Common Area Infrastructure Assessment

Hickory Woods, Londonderry

CLD Ref. No. 17-0224

Driveways/Pavement Scuffing

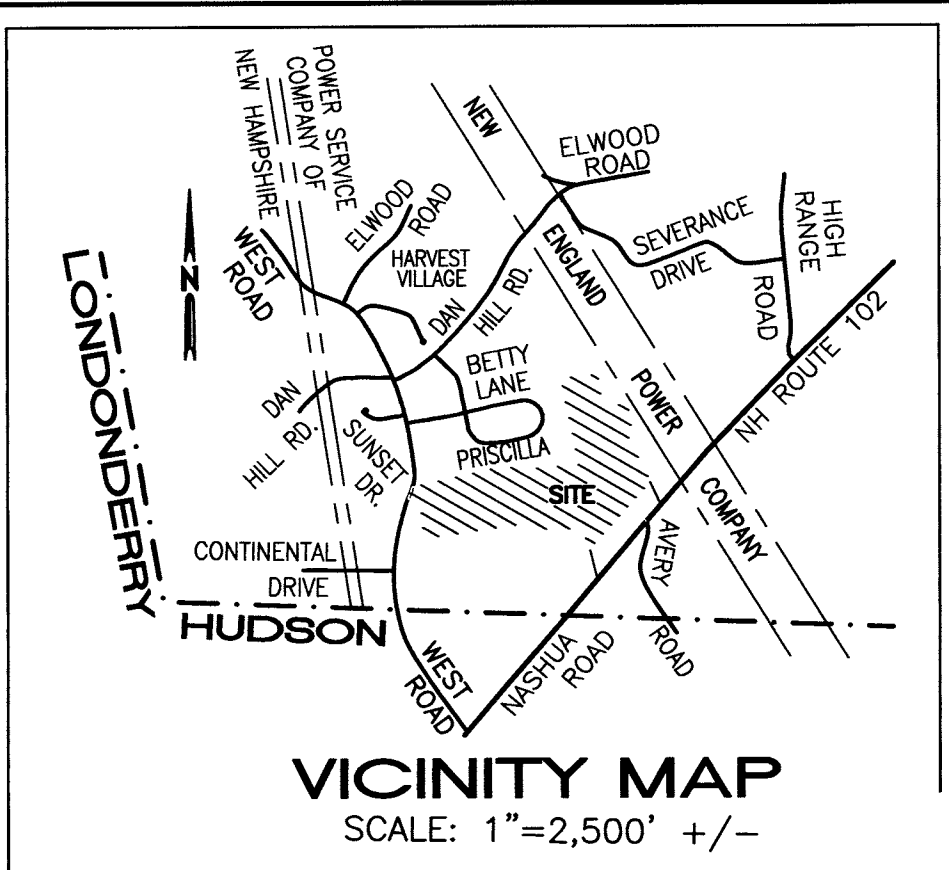
Some of the driveways have been constructed without removing or lowering the curb. Scrapes on some of the driveways indicate that this was causing vehicles to bottom out. It was observed that some of the driveways have been corrected, and some more driveways were in the process of being repaired during the site visit. The repairs were made by saw cutting the driveways approximately 5' from the curb line and repaving the last section driveway. These repairs should correct the concern; however an additional joint is created. These additional joints should be crack sealed to prevent failure at these joints.

It was also observed that these repairs were done approximately 5 weeks after the top coat of pavement was laid. Due to the heat of the summer the pavement is still somewhat soft and some scuffing and minor damage has occurred in the street adjacent to these driveways. Most of this is cosmetic, but it appears as if in some areas, small gouges were filled with asphalt. These gouges are likely to be the first to fail and create potholes in the future if not maintained.

Site Inspection Index Plan
by CLD Consulting Engineers
8-15-2017
Refer to Report for
details of each number

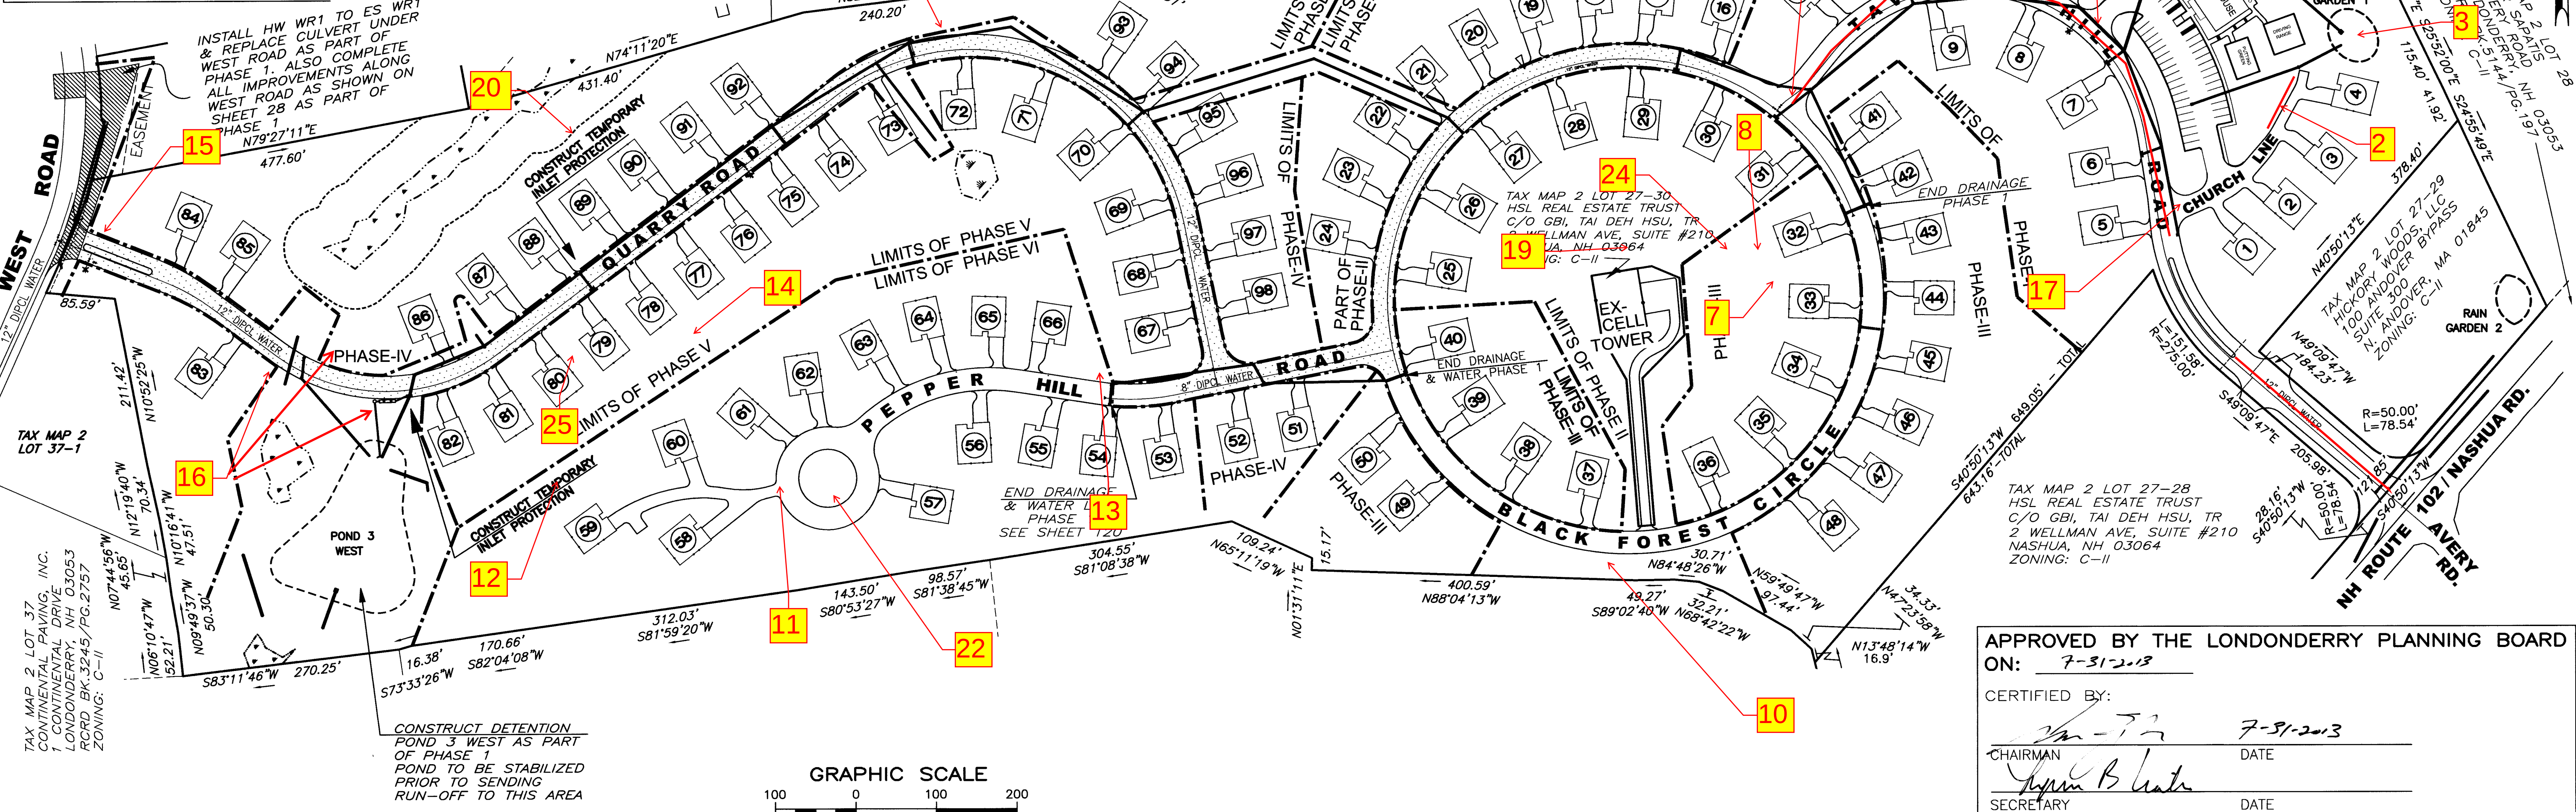
Refer to Site Inspection Index Plan for specific location.

3. Rain Garden #1: (End of Church Lane)

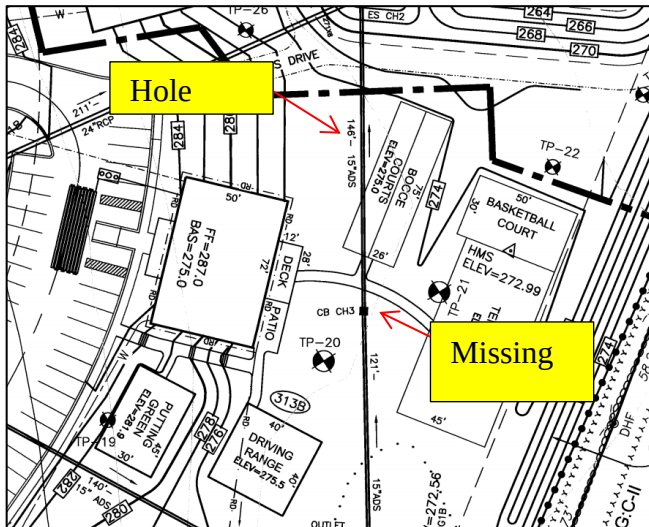
There are multiple deficiencies observed with Rain Garden 1 including the following:

- The outlet structure is missing its grate. This should be installed immediately.
- The PVC inlet pipe extends too far into the pond. This pipe should be cut back with a flared end section or at minimum riprap stabilization.
- There is sediment accumulated in the pond
- Where the edge of the sod from the neighbor's house meets the top of the pond is an abrupt drop-off which will likely erode in the future and be difficult to mow. We recommend blending the transition better.
- The back of the pond (opposite the outlet structure) is steeper than planned. It's unclear if this is due to ledge or a large boulder. This may be a cause for concern as the grass is slightly thinner than the rest of the area.
- The design plans call for a rain garden planted with shrubs and a mulch bottom. This appears to have been constructed as a typical detention pond.

7. Ledge Erosion behind unit 32

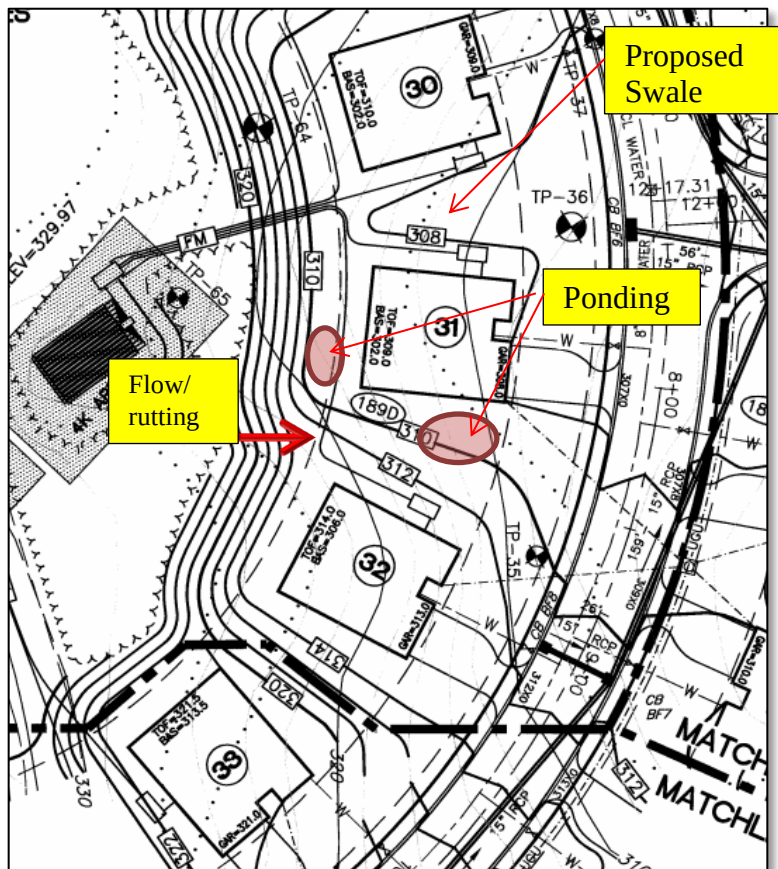
There is an area behind unit 32 (31 Black Forest Circle) that was blasted/hammered and is exposed ledge. While the ledge itself appears stable, there is exposed sand above the ledge and to the side of it that does not appear stable. This could potentially cause the trees above the ledge to fall down onto the house. The exposed sand should be stabilized somehow to prevent additional erosion and trees from falling onto the house. It is recommended that a geotechnical engineer inspect and provide recommendations.

12. Slope behind Unit 59

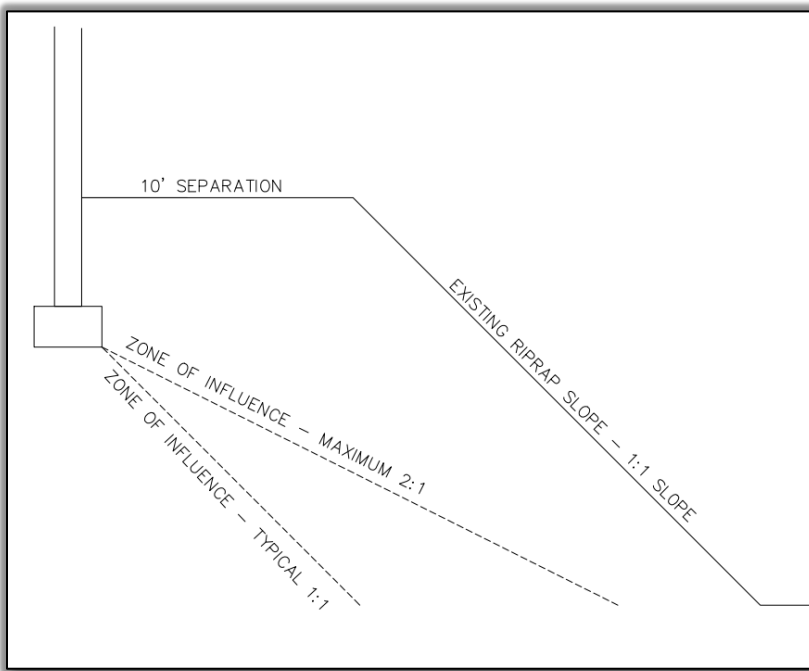
The slope behind unit 59 is fairly steep and fairly long. During our second visit we observed some minor rilling in the slope. On a follow up visit on July 26 the rills have partially stabilized, however the rills should have a bit more seed added and perhaps a short section of straw wattle to ensure the rills become fully stabile.

14. Septic/Slope behind units 77 & 78

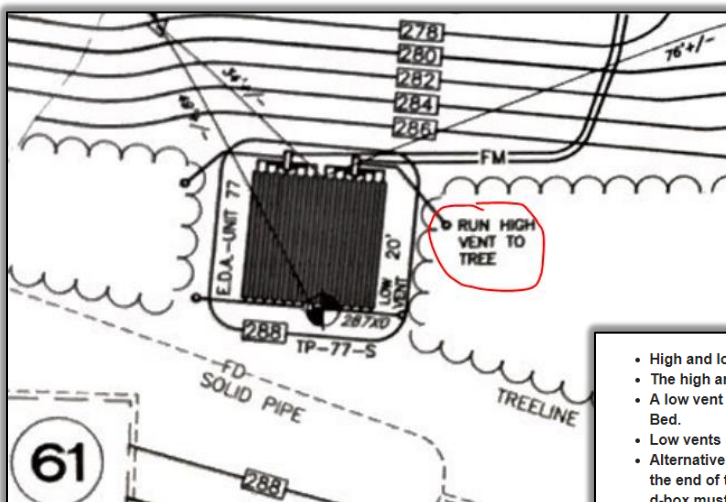
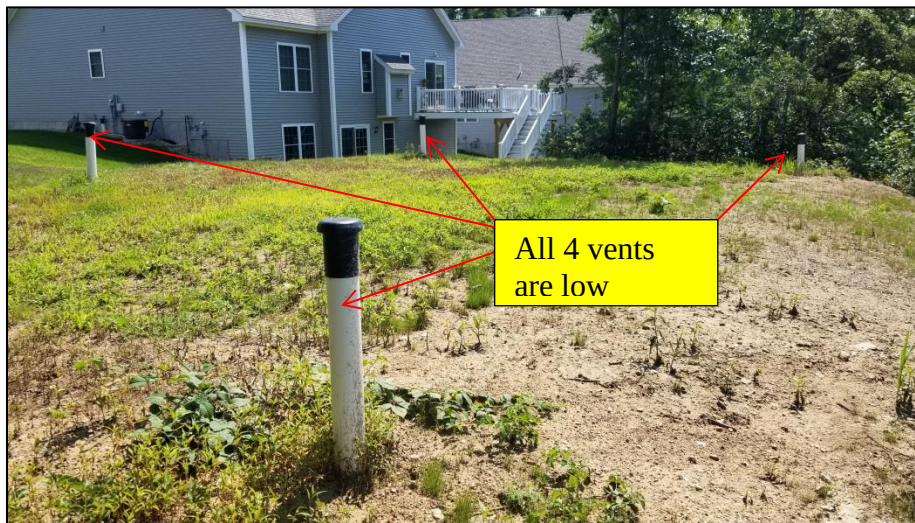
We inspected the slope behind units 77 and 78. This area was recently regraded. At the time of the initial inspection on July 9 it appeared to have been seeded. We visited a second time on July 26 and the seed has only partially started to vegetate. Due to the placement during the peak of summer it is anticipated that this seed will not take well until cooler weather occurs in September/October. Additional seeding will likely be required as birds, heat, and erosion have limited the amount of seed available to germinate. The plans also call for jute matting which has not been placed. Jute matting would help protect the seed and is recommended to be placed with an additional seeding in the late summer/early fall.

We also performed two auger holes to review any issue with the septic system. The first was in the sand at the edge of the leach field. The sand appeared dry and to meet the system sand specifications. The second auger was mid slope to look for seepage from the leach field. No seepage or signs of failure were observed. There was some dead grass noted at the bottom of the slope. This appears to be caused by sediment washing down the slope.

One noted deficiency is that the pumped leach fields were supposed to have a high vent off of the D-Box and a low vent off of the end of the leach field. In the field it was observed that there were 4 low vents. The high vents (off of the D-box) should be 10' higher than the low vent to allow for proper air circulation. This will cause the system to fail if not corrected. While most of the remaining septic systems were not inspected, the high vent/low vent differential should be completed at all pumped systems. Gravity systems only need the low vent as the high vent is run through the house.

- High and low vent openings must be separated by a minimum of 10 vertical feet.
- The high and low vents should be of the same capacity.
- A low vent is installed through an offset adapter at the end of each row, Section or Basic Serial Bed.
- Low vents should be a minimum of 3 ft. high or above snow line.
- Alternatively, the low vent may be attached to the d-box and the high vent may be attached to the end of the last AES or Enviro-Septic® row. If this configuration is used in cold climates, the d-box must be insulated to prevent it from freezing.
- A high vent is installed through an unused d-box outlet (see diagram below).
- Sch. 40 PVC or equivalent should be used for all high vents.
- All high vents should be at least 4 in. in diameter.
- All vents higher than 3' should be anchored.

18. Cracking around catch basin

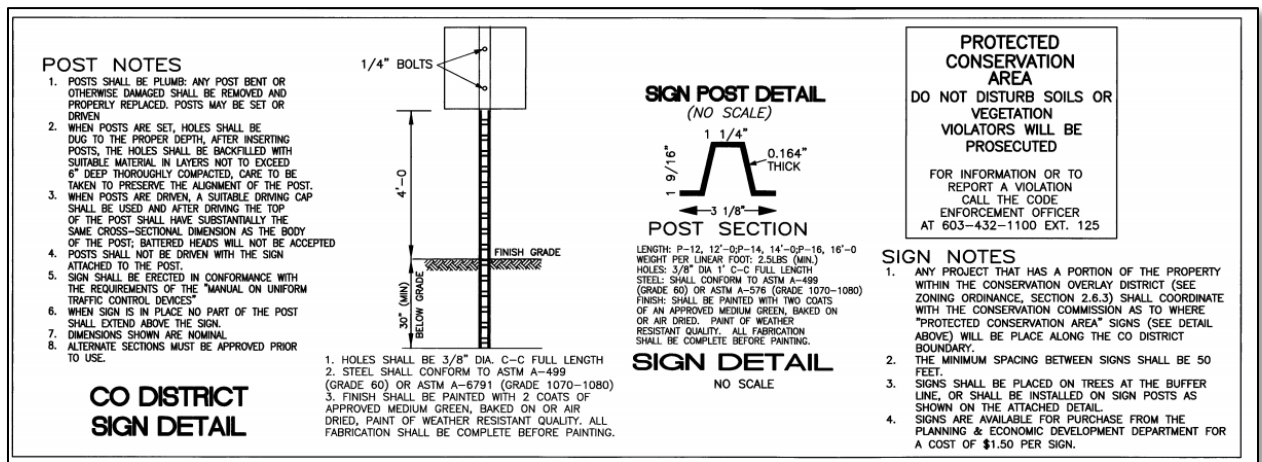
One catch basins at the intersection of Tavern Hill and Black Forest have received more cracking than would be considered normal. At a minimum these cracks should be crack sealed to prevent further damage and potholes.

22. Erosion at Pepper Hill Cul De Sac

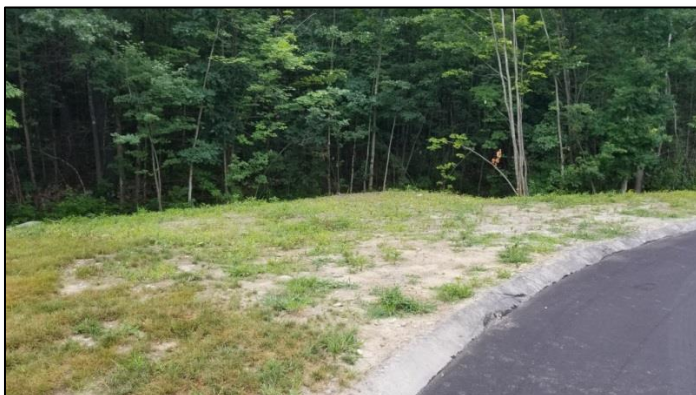
The center of the cul de sac on Pepper Hill Road and the south side of the cul-de-sac have not been stabilized and are in need of loam and seed.
